SERVICE BULLETIN

M1245

2008-2009 SPRINGER FORK ACORN STUD SAFETY RECALL 0139

Figure 1. Acorn Stud

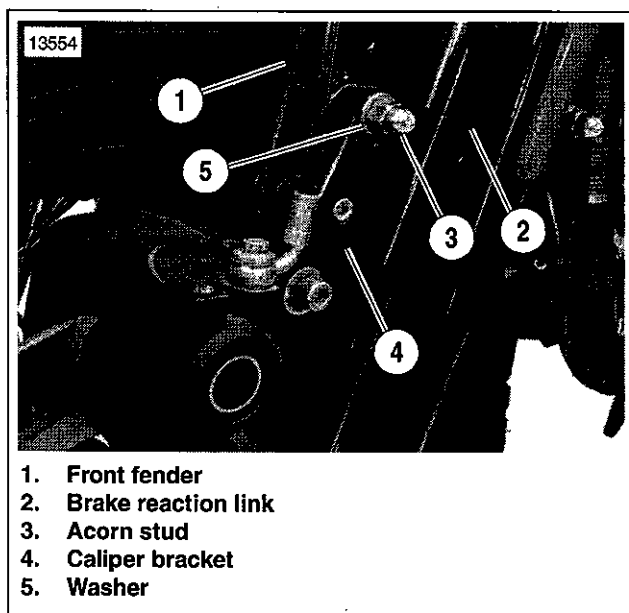
The acorn stud at the brake reaction link on the models listed above that were shipped before April 1, 2009 may fall out during use. If this occurs, the front brake and fender assembly would no longer be adequately retained.

1. Confirm motorcycle is involved and that campaign 0139 is open.
2. See Figure 1. Support brake reaction link (2) and remove acorn stud (3) and washer (5). Discard acorn stud (3). Retain washer (5).
3. Install **new** acorn stud, supplied in kit, and washer (5) through caliper bracket (4), brake reaction link (2), and front fender (1). Tighten acorn stud to 35-40 ft-lbs (47.5-54.3 Nm).
